**From:** Casey, Colleen  
**Sent:** Tuesday, September 15, 2015 4:41 PM  
**To:** 'tlautenbach@mtc-test.com'  
**Subject:** Request for additional information - 588496  
**Attachments:** Scan001.PDF

ORGANIZATION Materials Testing Consultants, Inc.	DOCKET NUMBER(S) 03013918
---	------------------------------

LICENSE NUMBER(S) 21-15281-02	CONTROL NUMBER(S) 588496
----------------------------------	-----------------------------

SUBJECT  
Additional information needed for review of your amendment requests

**Figure 8.1 RSO Responsibilities. Typical duties and responsibilities of RSOs.**

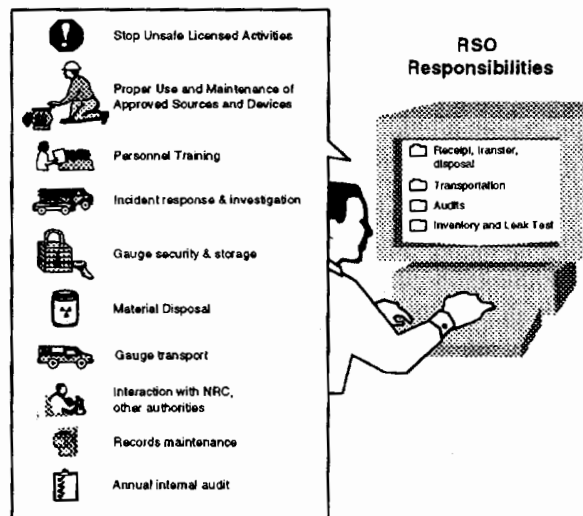
3. How will Mr. Lautenbach exercise oversight of the radiation safety program at temporary job sites? Please be specific.
4. Please see the attached page from NUREG 1556, Vol. 1, Rev. 1, Appendix E, about RSO duties and responsibilities. It appears that most of these duties and responsibilities were not described in your application dated August 6, 2015. →

Please specify the duties and responsibilities that your proposed RSO will be tasked with, focusing on those in Appendix E.
